**ADDENDUM
NO. 3**

September 11, 2024

**LOGANSFORT JR. HIGH SCHOOL RENOVATIONS
Logansport, IN 46947**

© GIBRALTAR DESIGN SHEET
C EL103

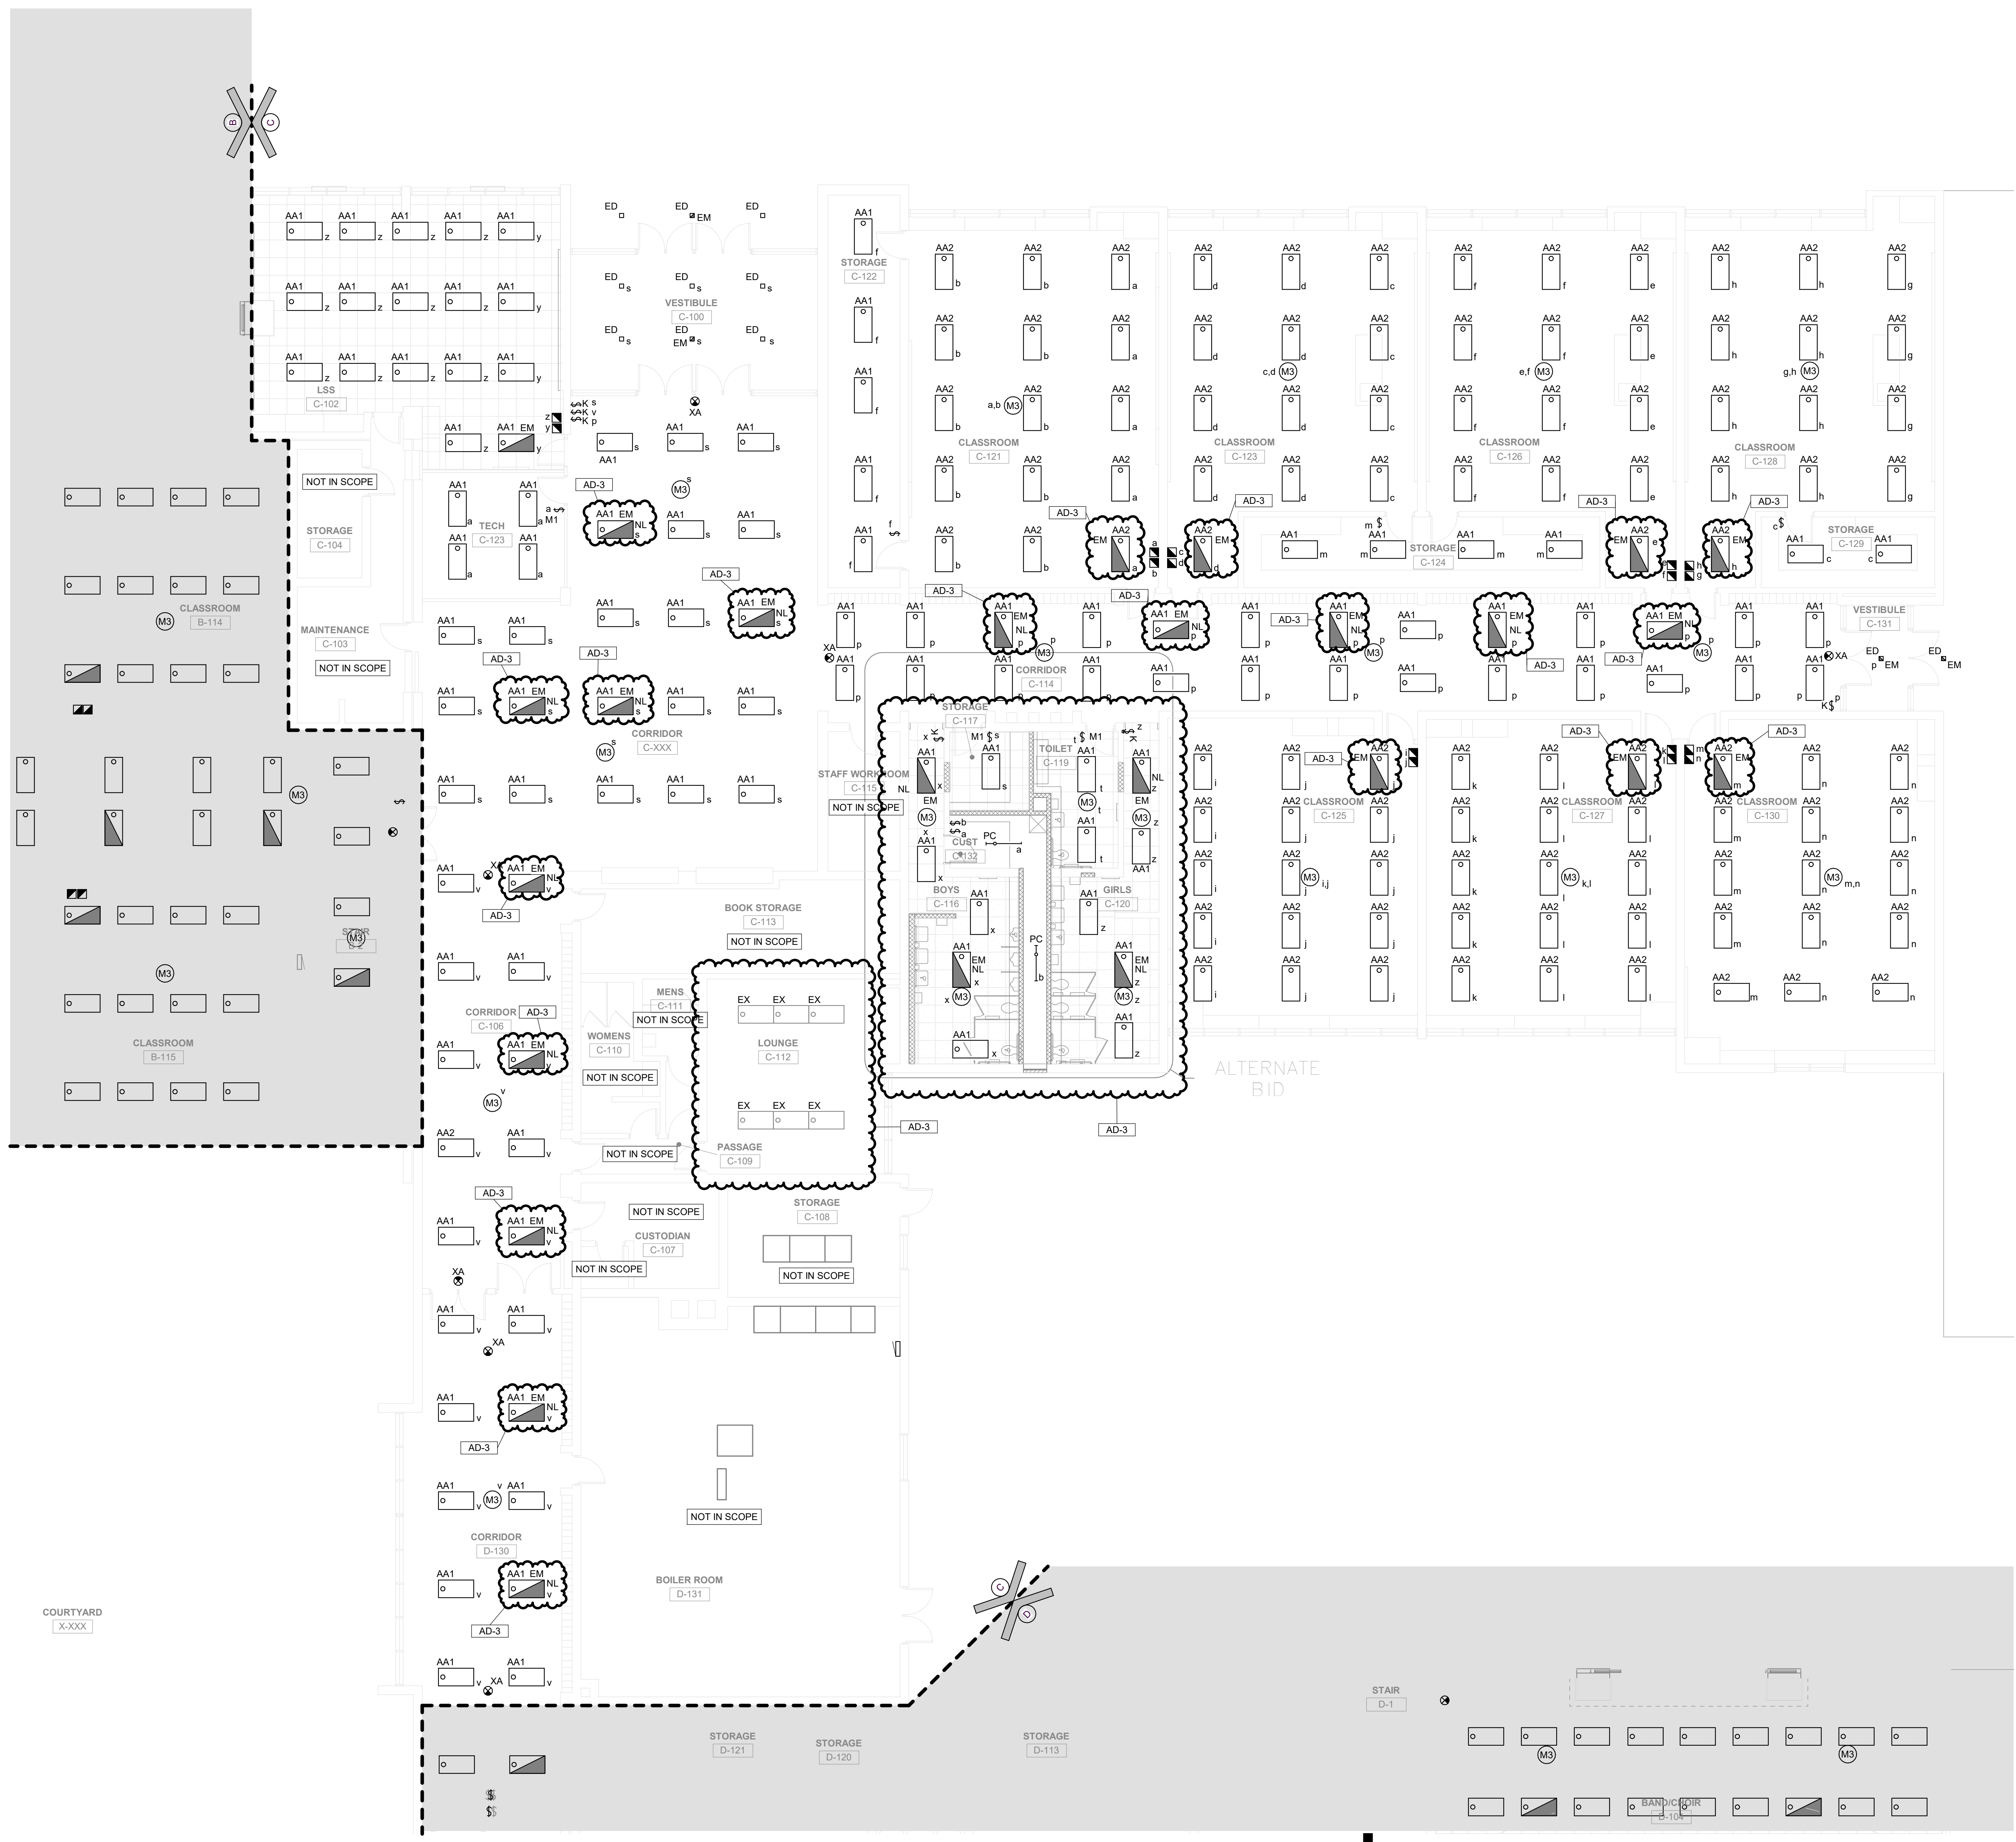
- A. Added emergency lighting in all classrooms.
- B. Omitted lighting scope in Lounge C-112.
- C. Added Alternate Bid to toilets including Storage C-117.

1 UNIT "D" FIRST FLOOR ELECTRICAL LIGHTING PLAN
EL104 1/8" = 1'-0"

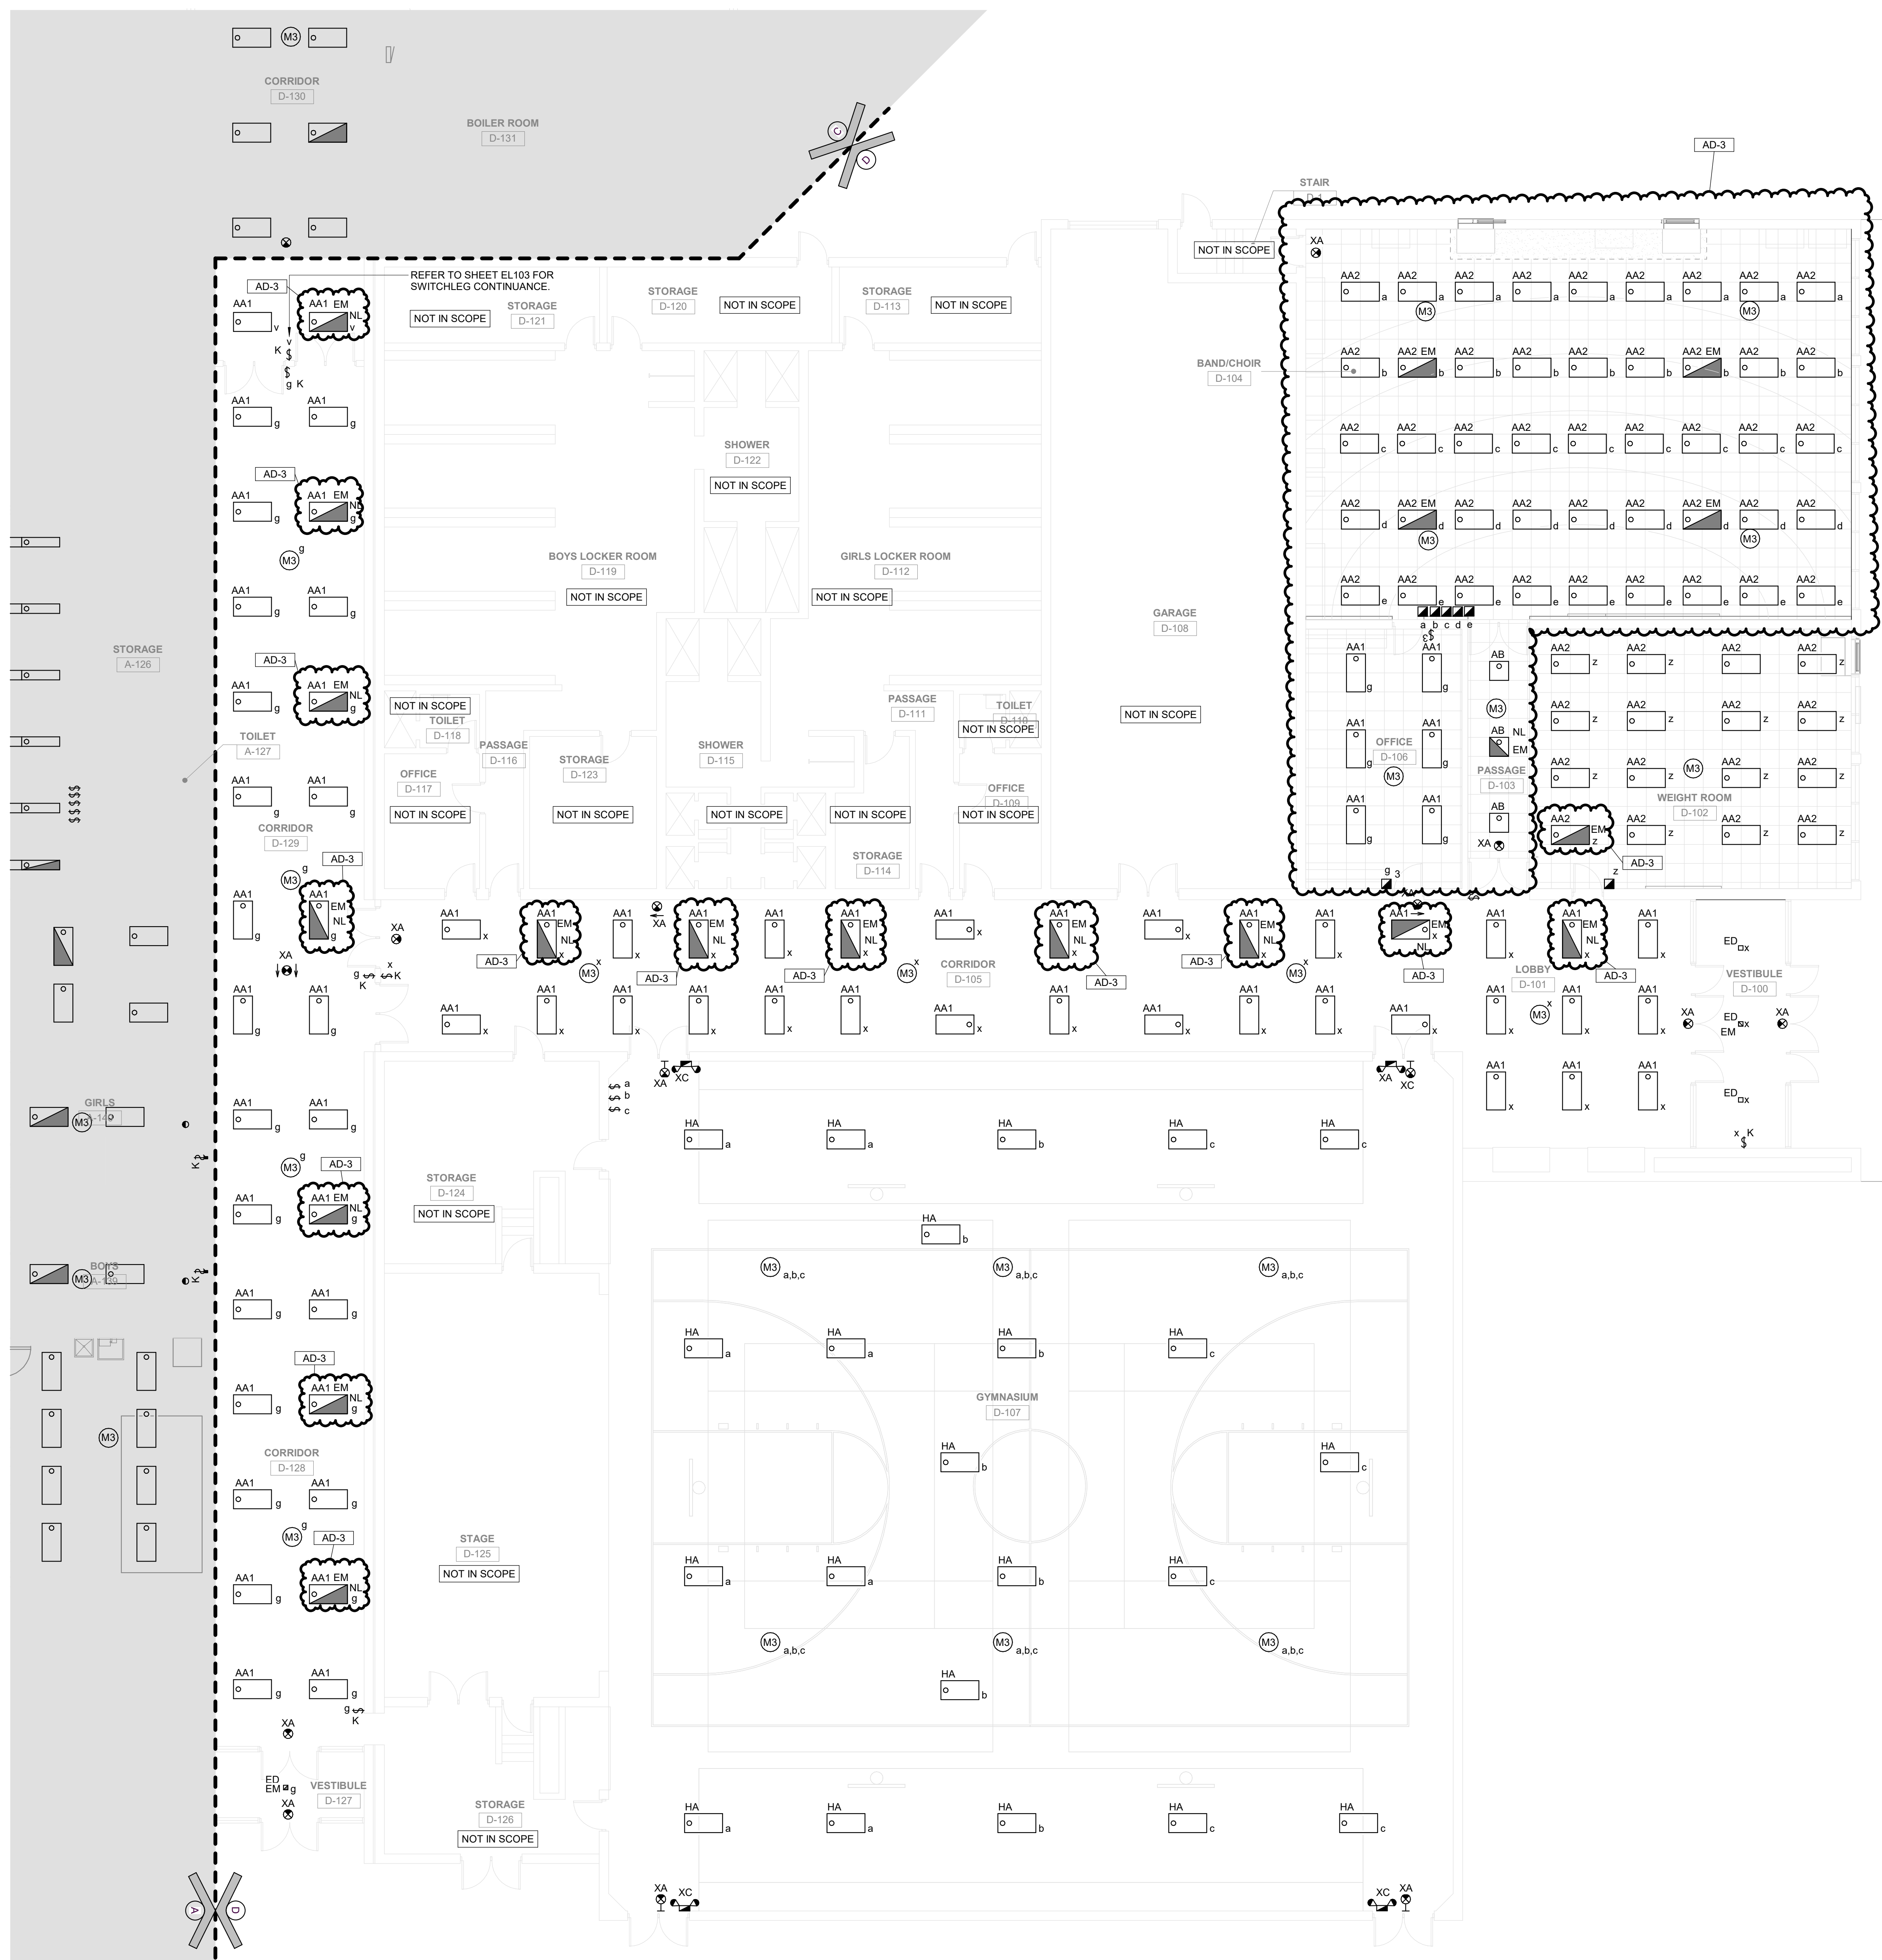
- A. Added emergency lighting in all classrooms including Weight Room D-102
- B. Added Lighting scope in Bandshell D-104, Office D-106 & Passage D-103

GIBRALTAR DESIGN SHEET
A EP101

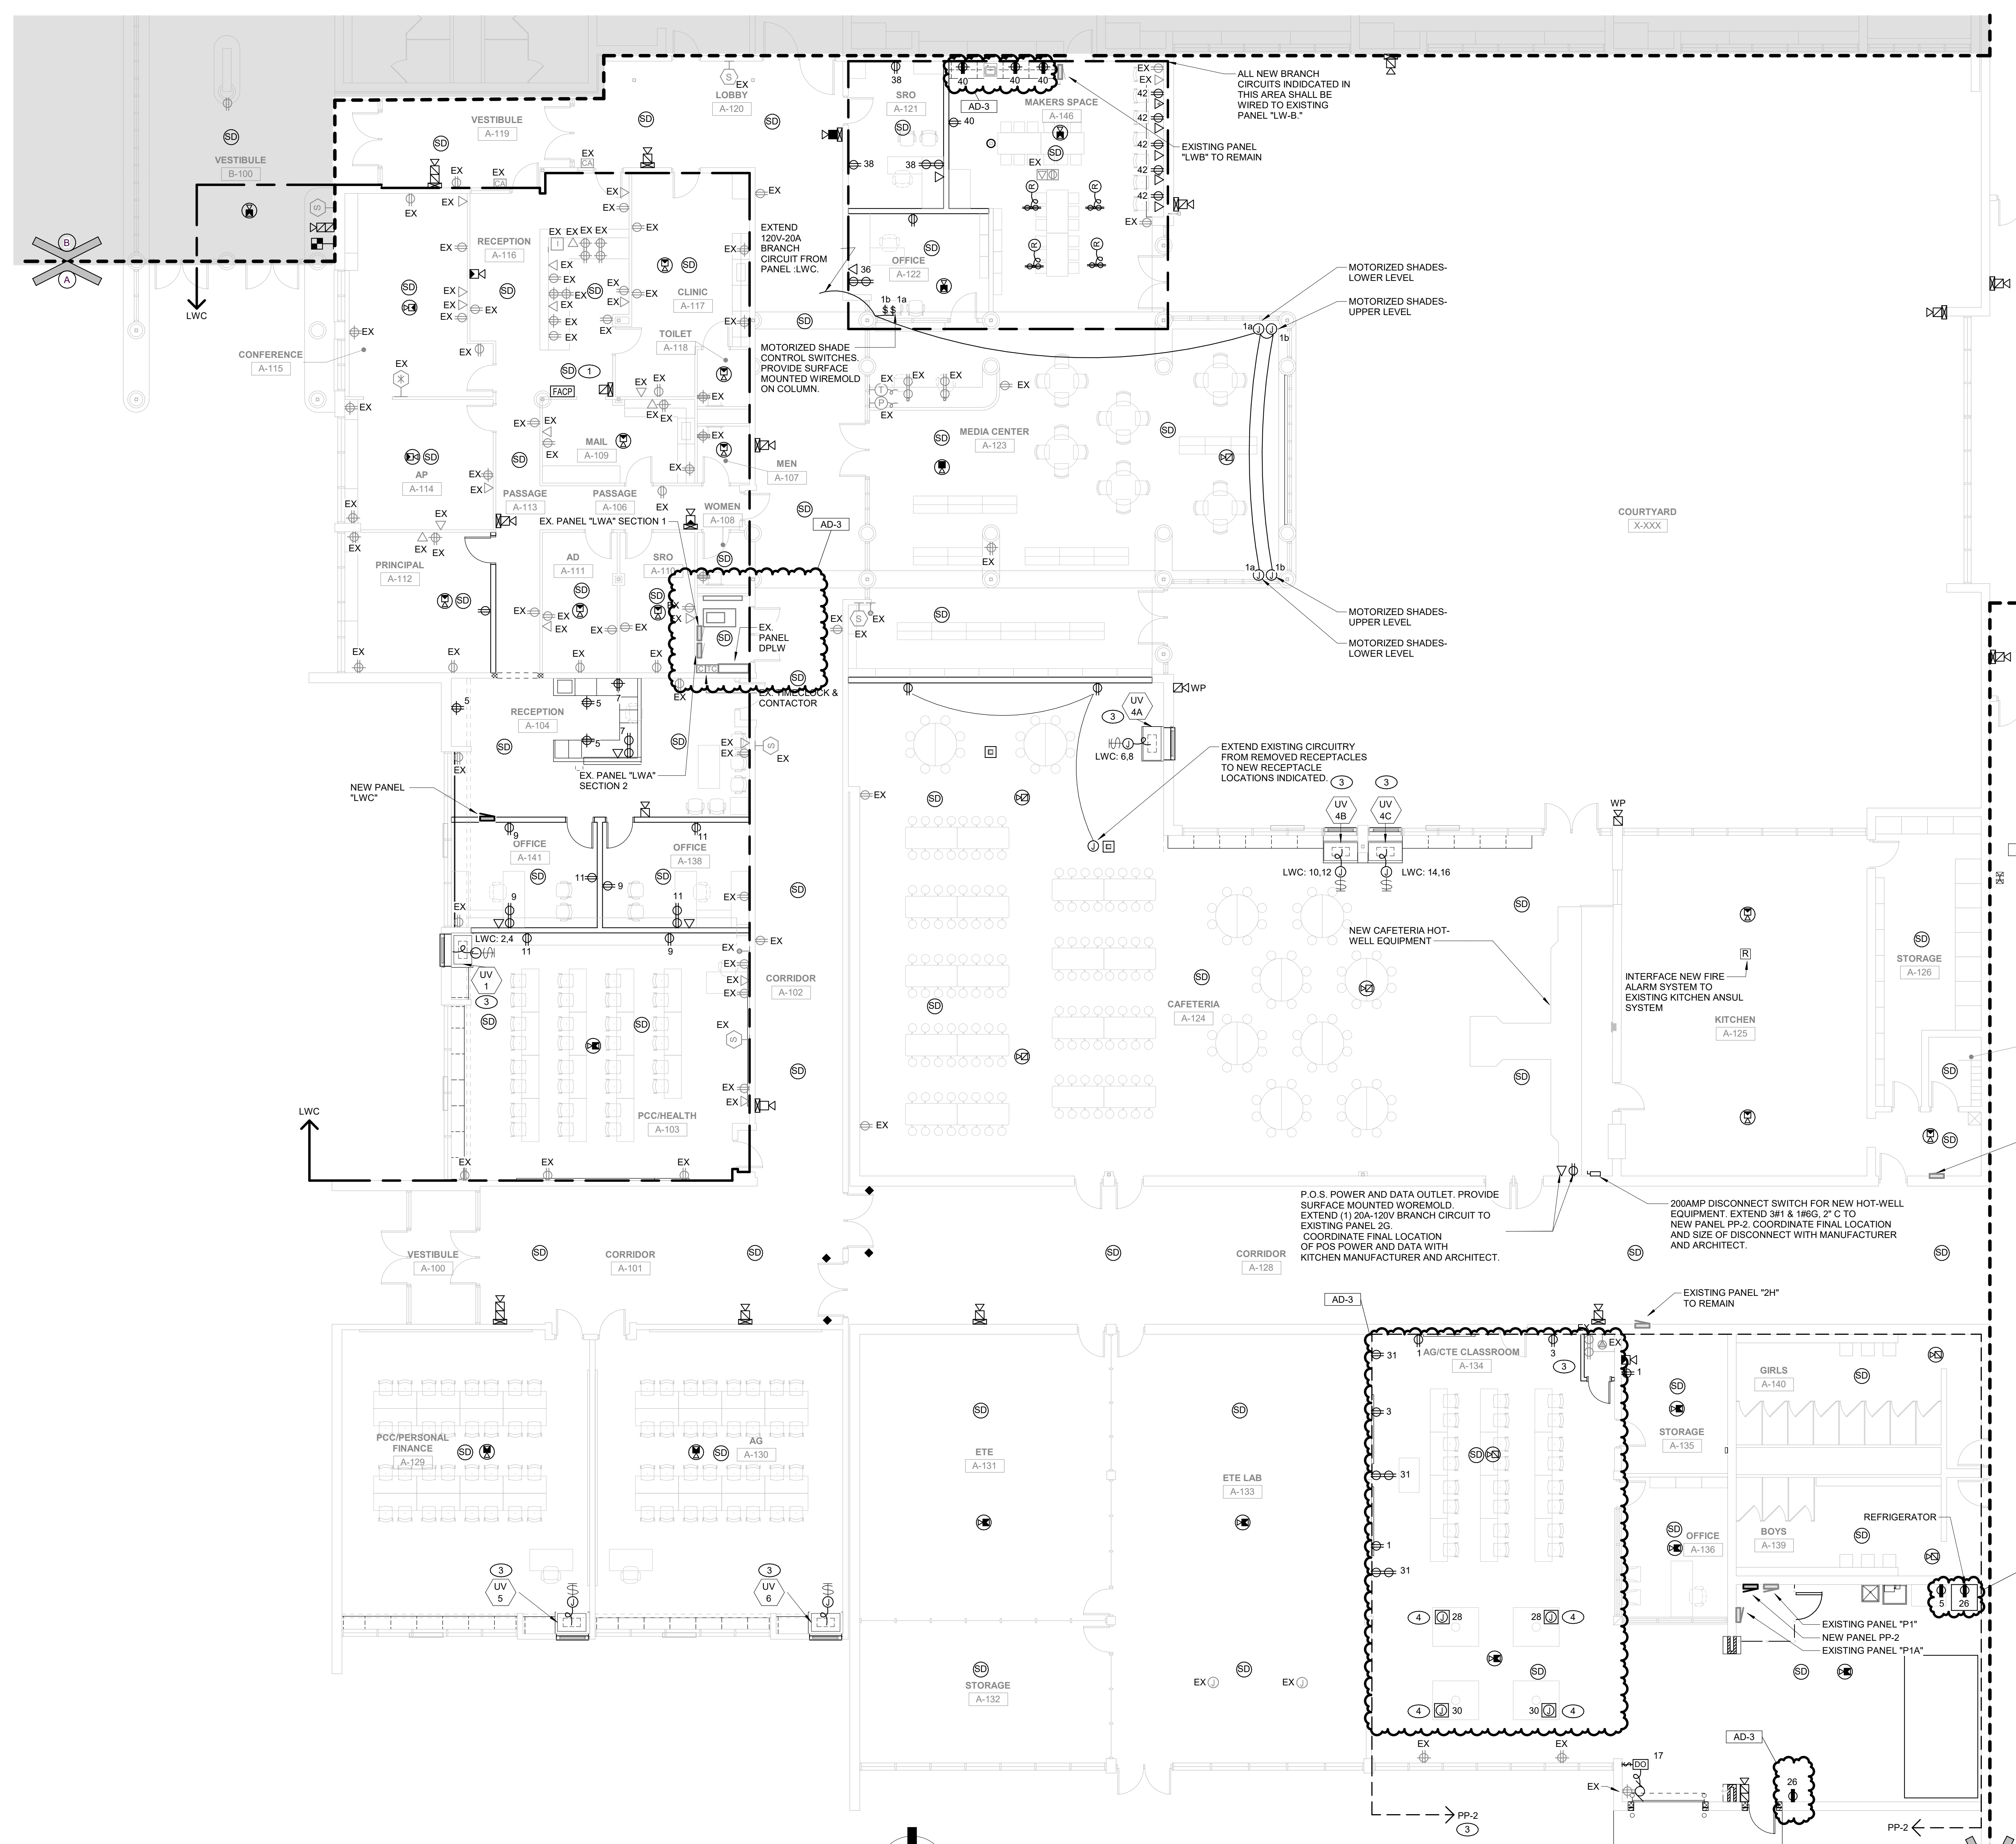
- A. Added low voltage scope.
- B. Added power scope at AG/CTE Classroom A-134.
- C. Added receptacles to Makers Space A-1456.
- D. Clarified location of existing panel EX .DPLW.
